**PERMIT**Please Read  
Application And  
Notes, If Any,  
AttachedThis is to certify that BRADFORD ALLEN E JR & WHITNEY FORD JTS are thehas permission to Single Family Home - Stick built 30' x 34' Colonial 23' x 24' Attached garageAT 401 ALLEN AVE City of Portland Permit Number 401 A014001

Permit No: 08-1302	Issue Date: 11/13/08	CBL: 401 A014001
-----------------------	-------------------------	---------------------

**Dept:** Building      **Status:** Approved with Conditions      **Reviewer:** Chris Hanson      **Approval Date:** 11/04/2008

# 401 Allen Ave.

**24' Cape Garage Cross Section**

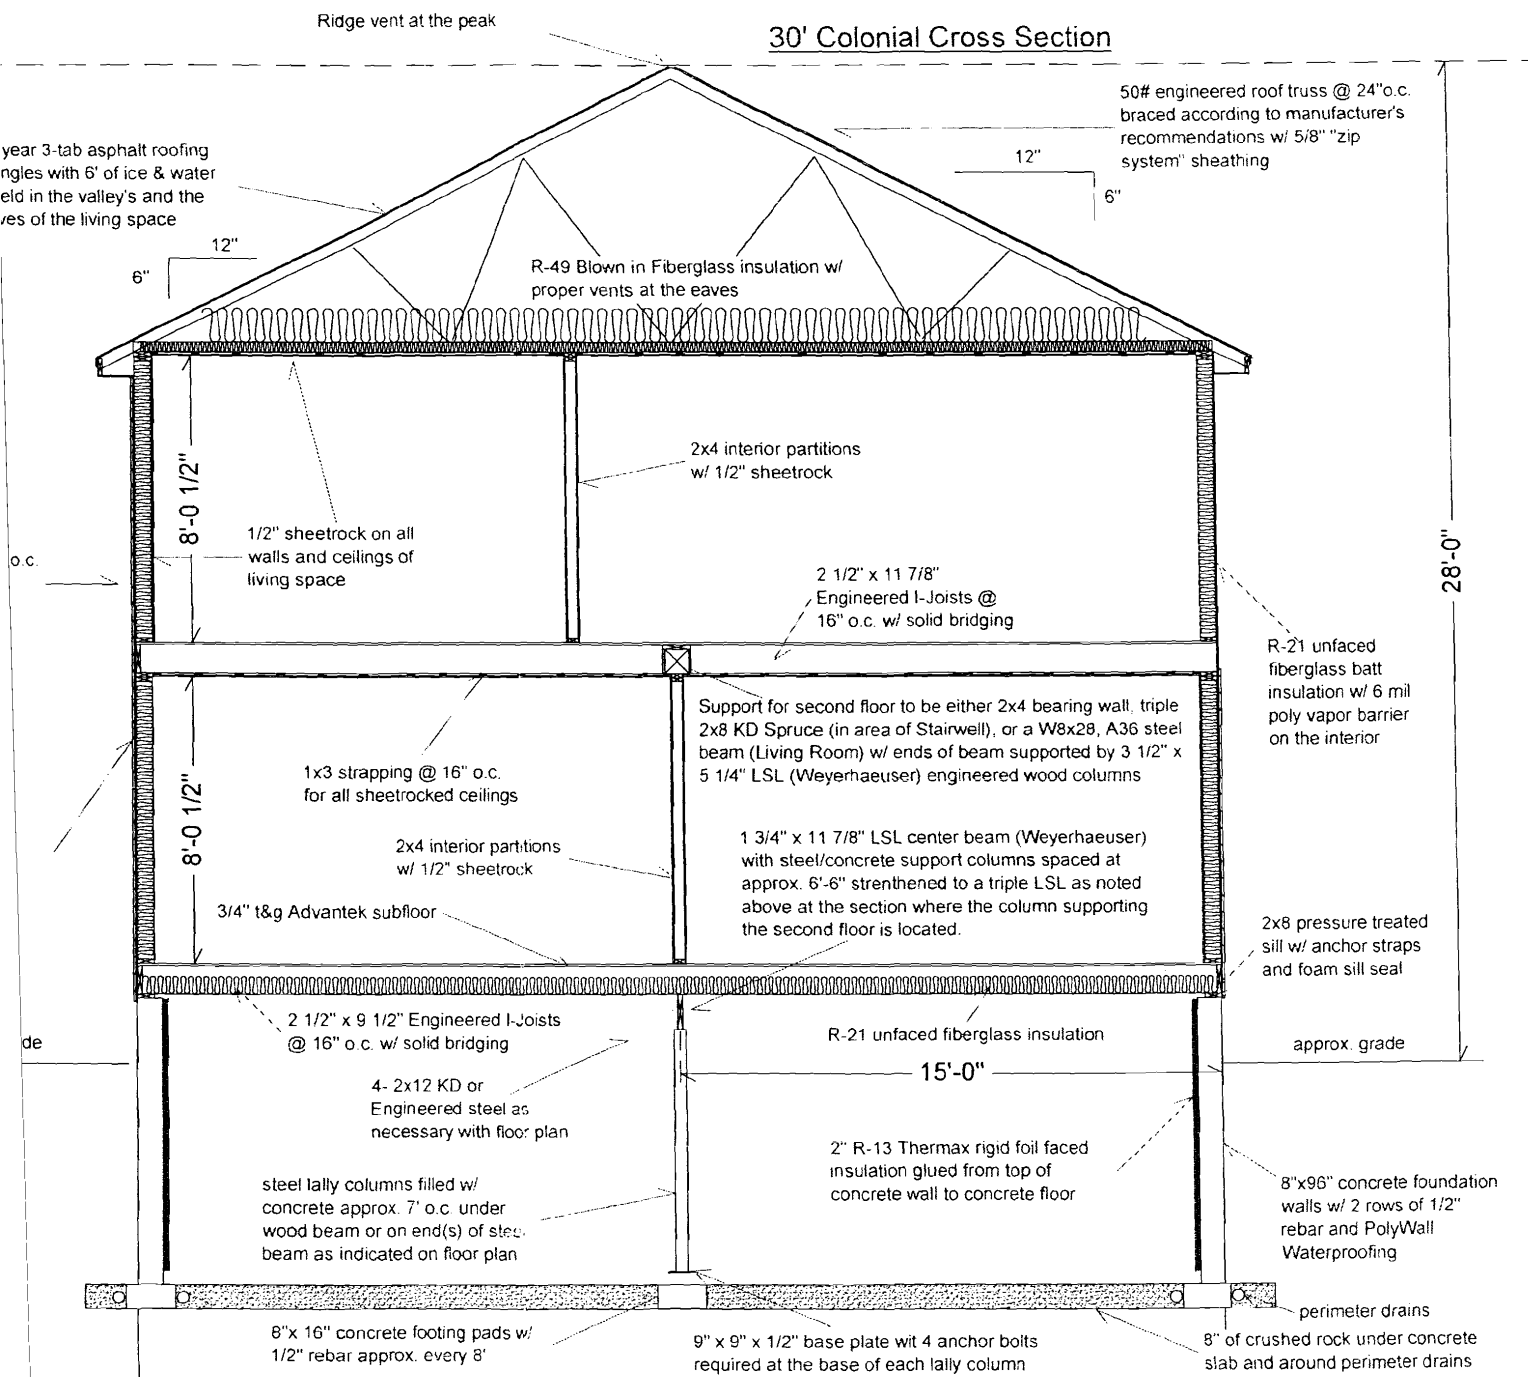
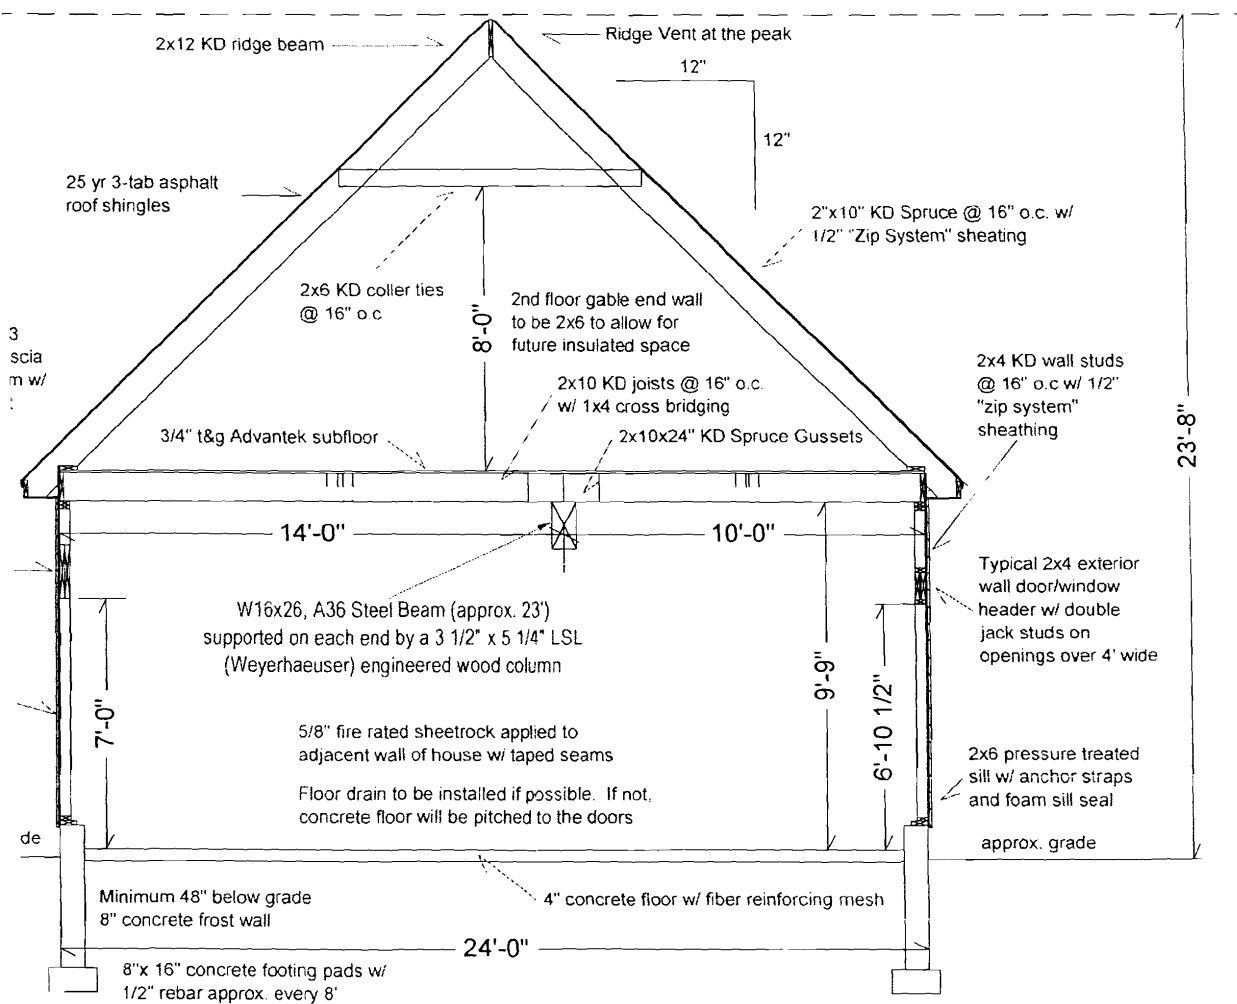
- ✓ 1. Survey letter confirming bldg. loc.  
(sides 14.5 / 14 min.)
2. 2006 - Letter from eng. - should be  
2003 - IRC. revise.
3. No floor drain - pitch floor
4. Attic access 22x30 R 807
5. WRAP Steel beam w/ 5/8" sheetrock ✓
6. Garage walls 1/2" sheetrock
7. uplift connectors on trusses req. ✓

**Exterior Deck/Step Detail w/ Railings****Fire Separation Detail  
(not to scale)**

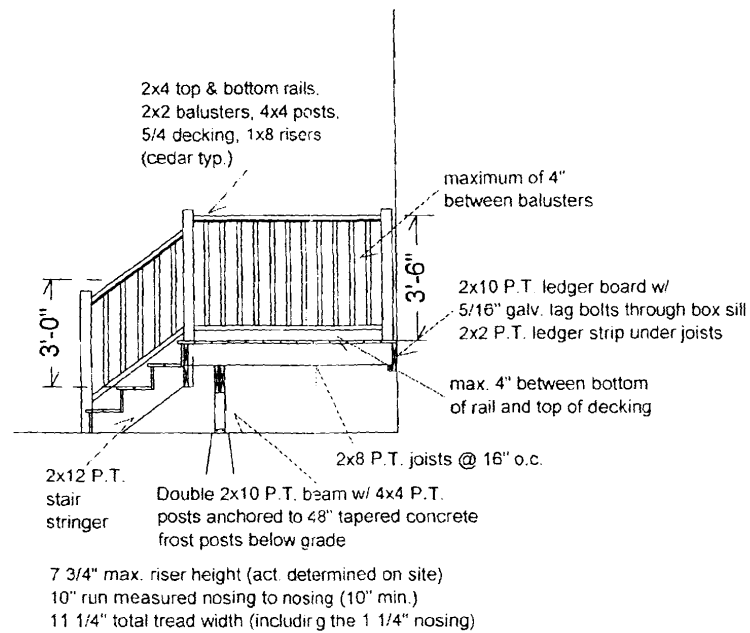
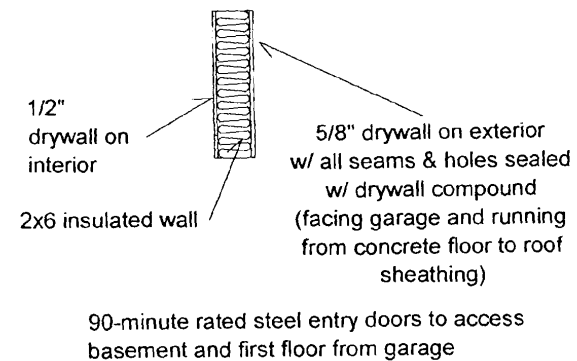
- 10) Uplift connectors required per manufacturers installation requirements
- 11) Steel beam must be protected in garage w/ 5/8" sheetrock
- 12) The owner and builder agree to submit a statement from a licensed surveyor PRIOR to placement of backfill stating the location of the structure is compliant with the City of Portland required setbacks.
